**HILLSIDE AT LORSON RANCH**

**EARLY OVERLOT GRADING / EROSION CONTROL PLANS**

Engineering Review  
03/30/2022 8:50:30 AM  
dsdrice  
JeffRice@elpasoco.com  
(719) 520-7877  
EPC Planning & Community  
Development Department

**COVER SHEET  
EARLY GRADING AND  
EROSION CONTROL PLAN**

FOREBAY DETAIL  
NO SCALE

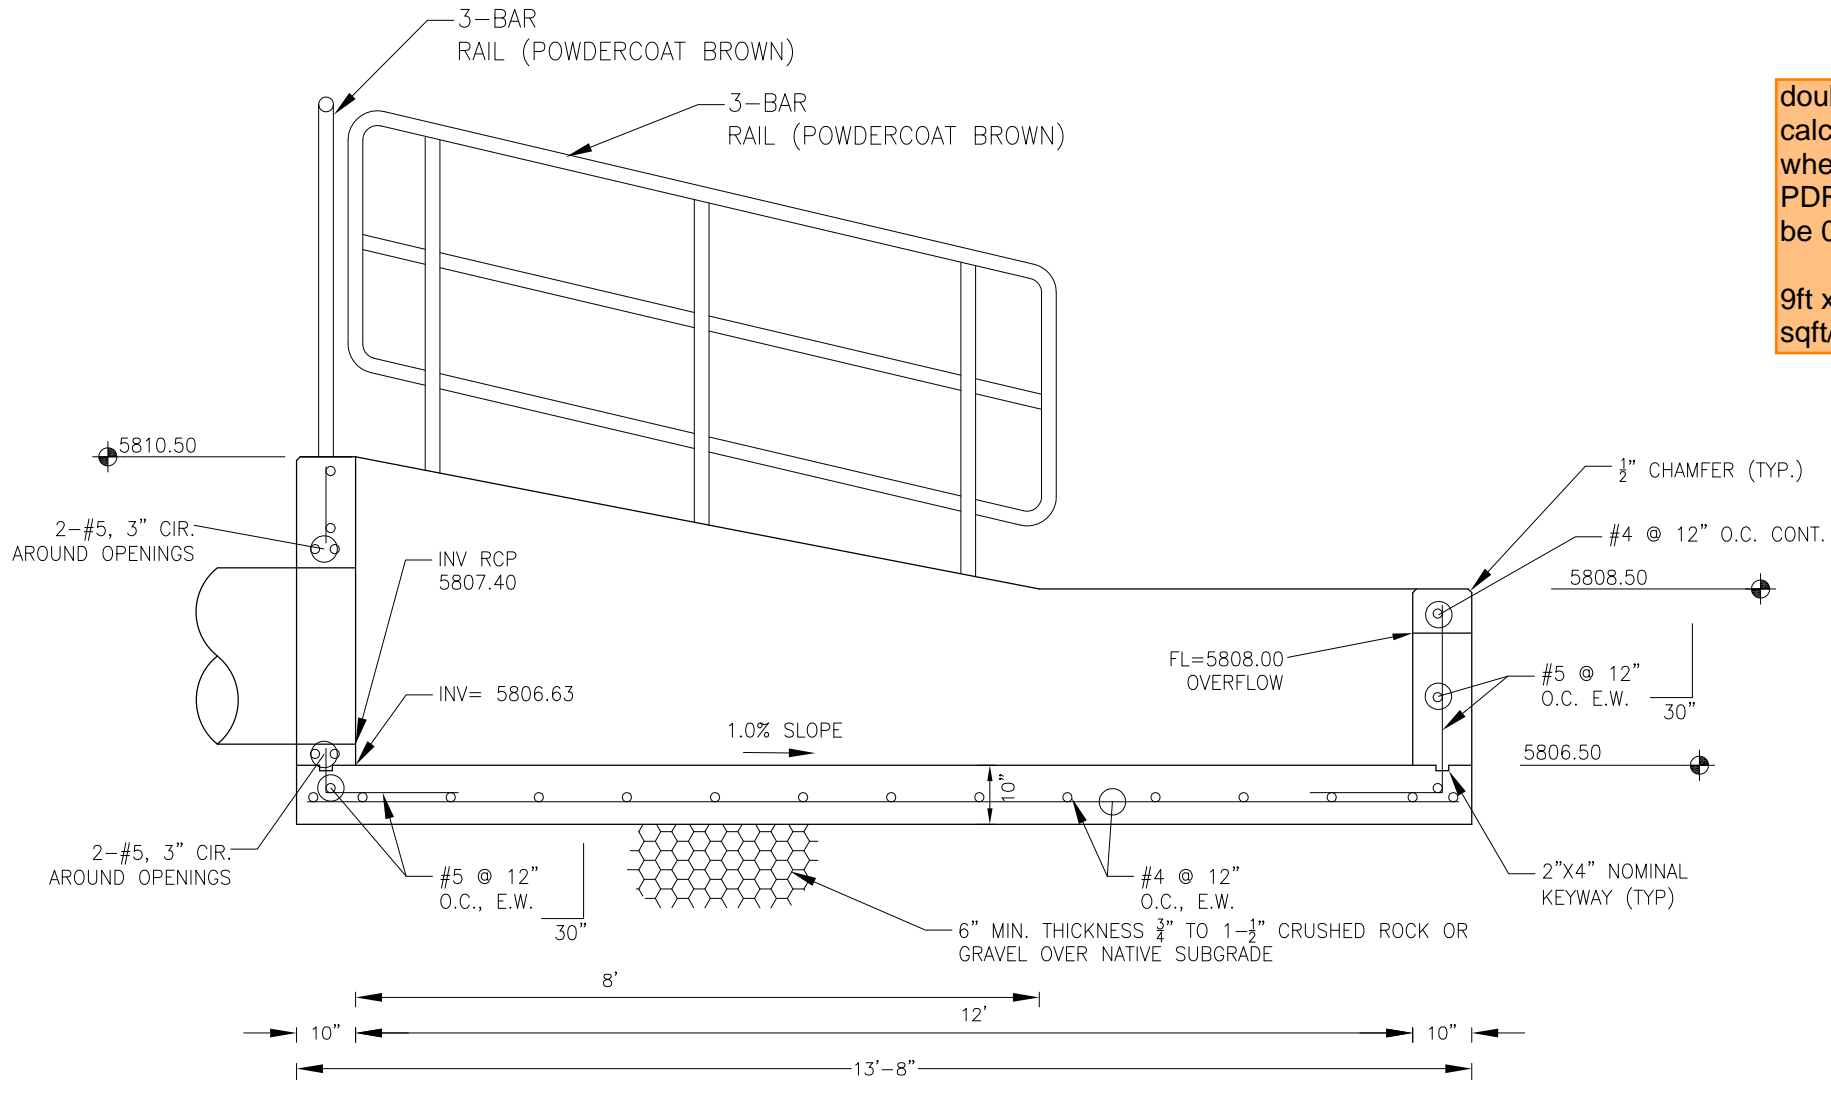
double check volume calcs. I get 0.005 ac-ft, whereas pdf pg 135 of PDR states min should be 0.006 ac-ft.  
 9ft x 12ft x 2ft / 43560 sqft/ac = 0.005 ac-ft.

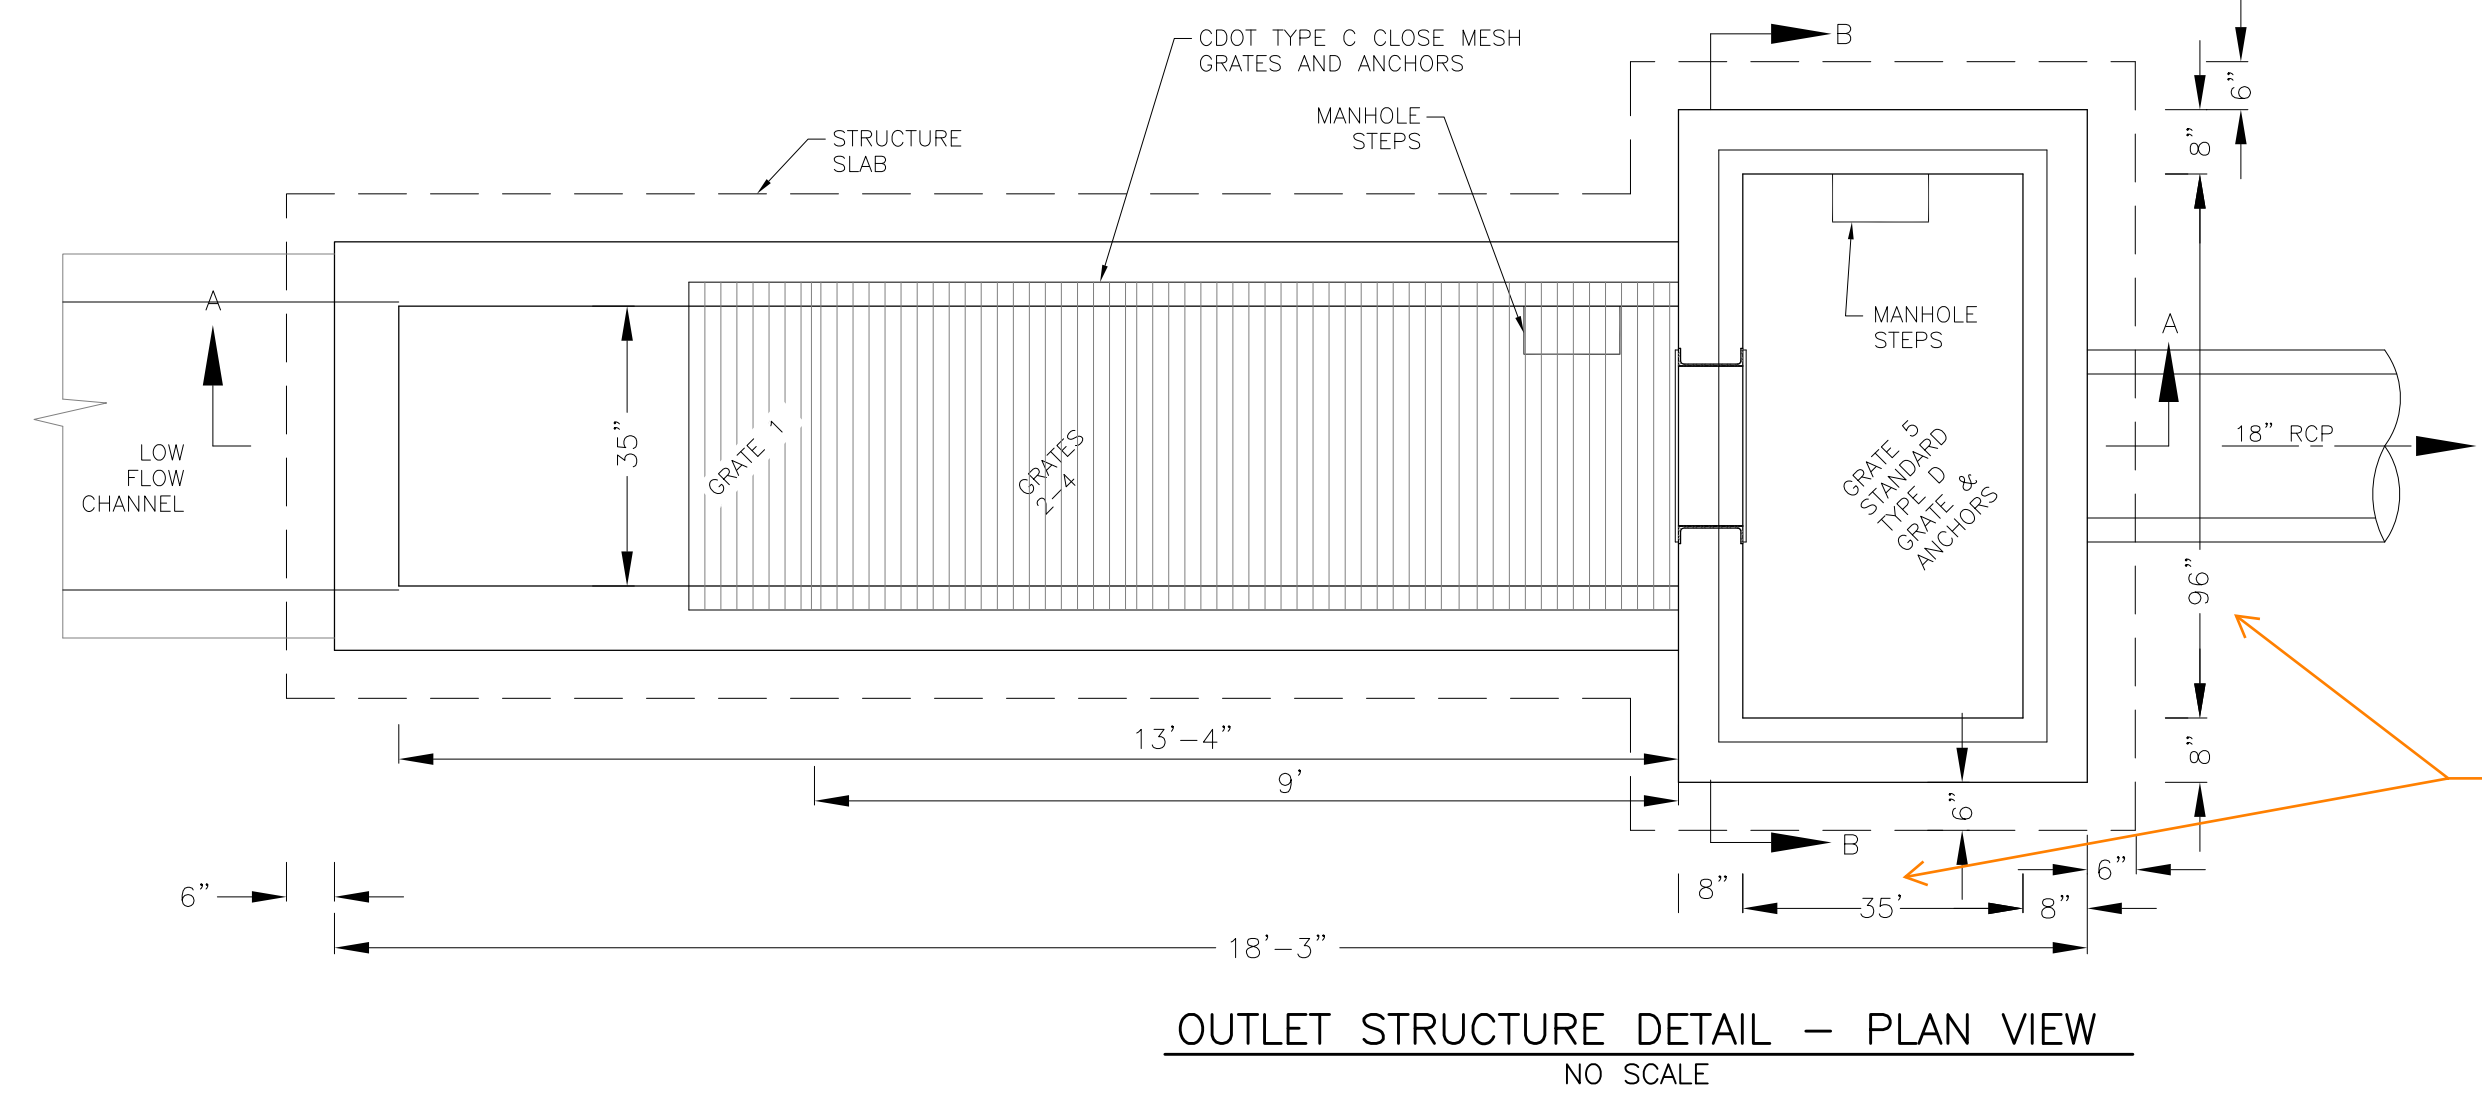
Remove "WQ." Per pdf pg 28 of the PDR, this is a full spectrum detention pond, not a WQ Pond.

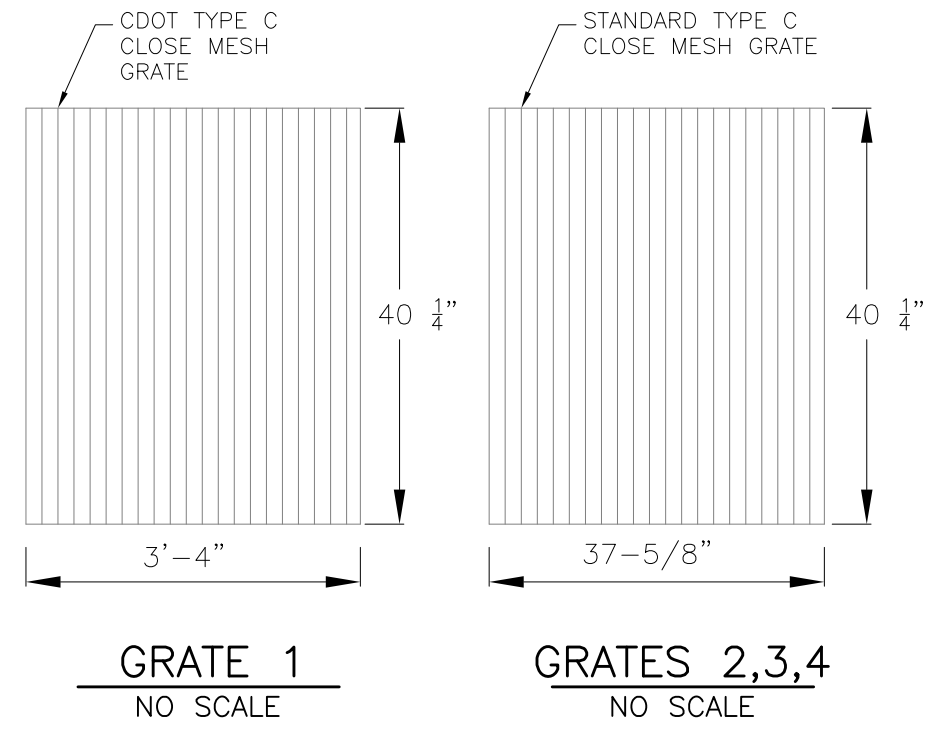
pdf pg 131 of PDR actually shows length and width switched (ie: box turned 90 degrees). Revise on here or in FDR.
